# ACCELERATED DISTRIBUTION DEMONSTRATION SYSTEM

SUBJECT: Forwards licensee response to questions discussed during  
 891017-19 audit re resolution of station blackout issue.

L-90-56

Re: Turkey Point Units 3 and 4  
Docket Nos. 50-250 and 50-251  
Information to Resolve Station Blackout

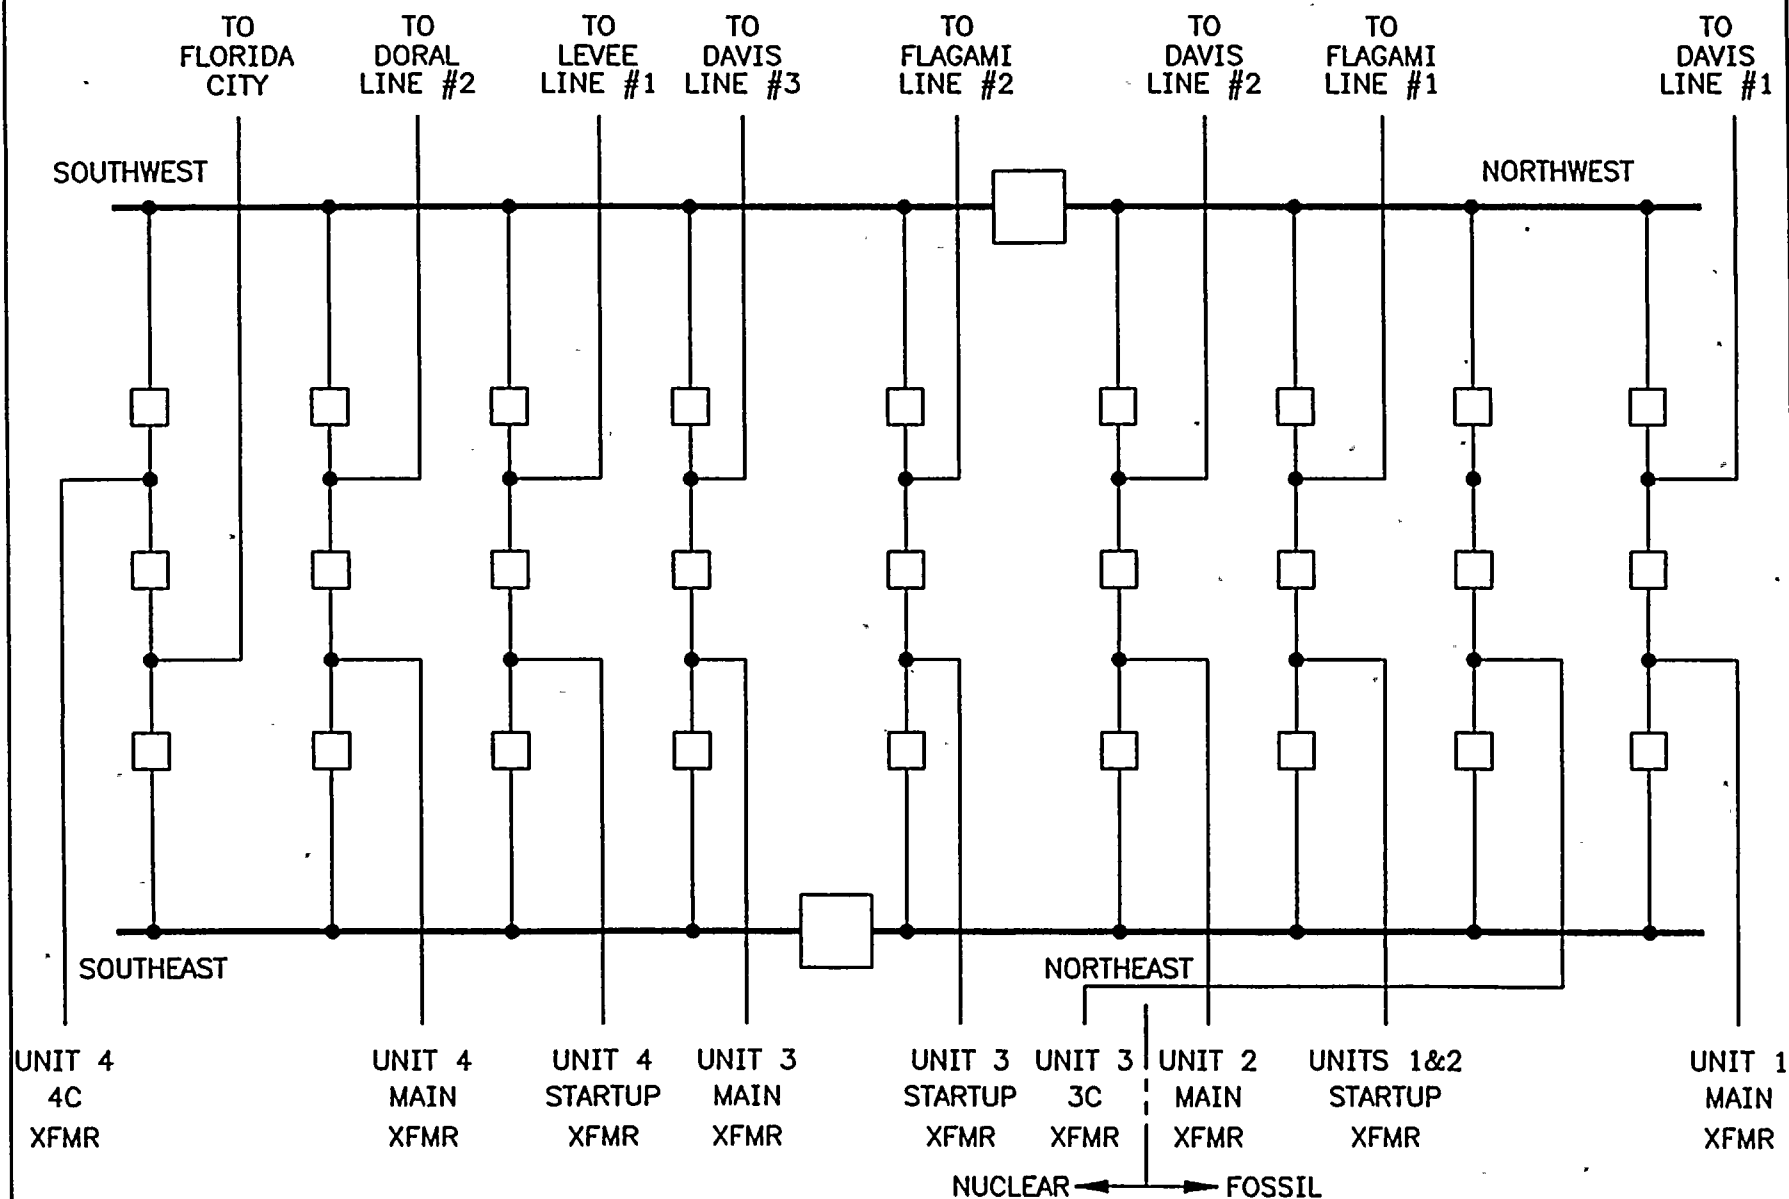
Discuss how the plants meet (will meet) the offsite power system Group II criteria by referring to NUMARC 87-00 page 3 11 or Regulatory Guide 1.155 Table 5, p.12.

FPL has concluded that the existing configuration of the Turkey Point Units 3 and 4 offsite power sources places Turkey Point into an I1 or I2 category of Regulatory Guide 1.155, Table 5. An I1 or I2 category does not affect the final categorization of Turkey Point Units 3 and 4. This determination is based on the following Regulatory Guide criteria:

- o Turkey Point has eight separate 240KV incoming transmission lines on two different right of ways. These lines come from five different substations.
- o The Turkey Point switchyards have four independent buses; southwest, northwest, southeast and northeast. Existing breakers provide the required isolation and independence between these buses to electrically separate the incoming lines.

Seven of the eight 240 kV circuits out of Turkey Point are on a common right of way that follows a route roughly north-west in direction from the site. These 240 kV circuits are carried on four transmission line structures each consisting of two concrete poles with steel cross arms. Three of the structures carry two outgoing 240 kV circuits each, and the fourth carries a single 240 kV circuit. The structures are designed to carry two 240 kV circuits and to withstand hurricane winds up to 187 MPH. They have successfully withstood without any damage the severe hurricane Betsy in 1965.

FIG. 9.11-1

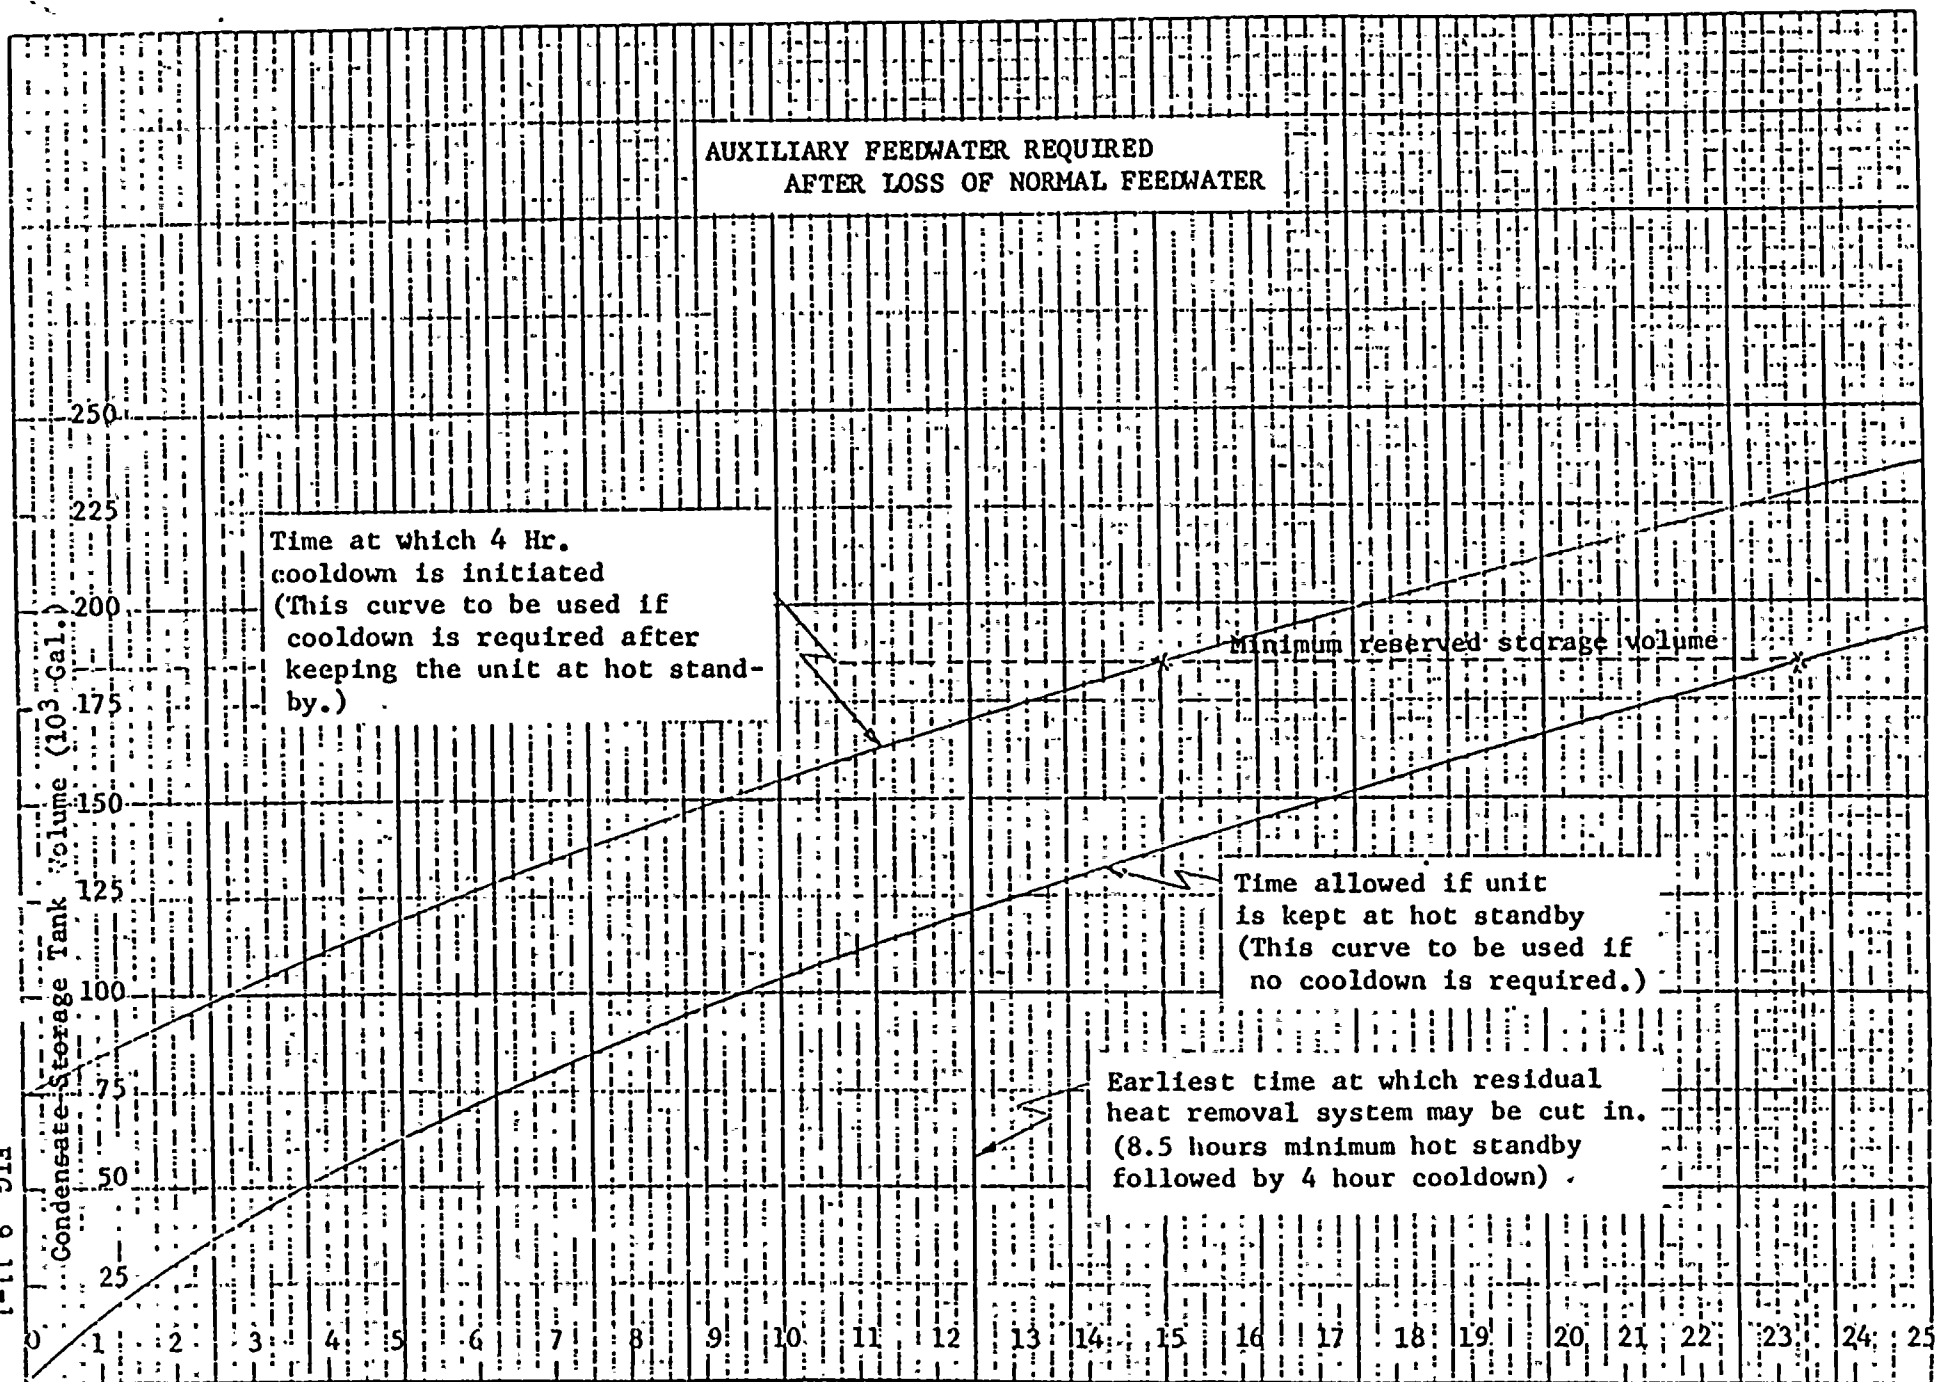
Provide the number of gallons of water required for decay heat removal during the four-hour coping duration and the minimum permissible condensate storage tank level per Technical Specifications. If additional water sources are necessary for decay heat removal, identify these, list the number of gallons provided by each source and identify any plant modifications and/or procedure changes needed to utilize these water sources.

This is shown graphically in Figure 9.11-1.
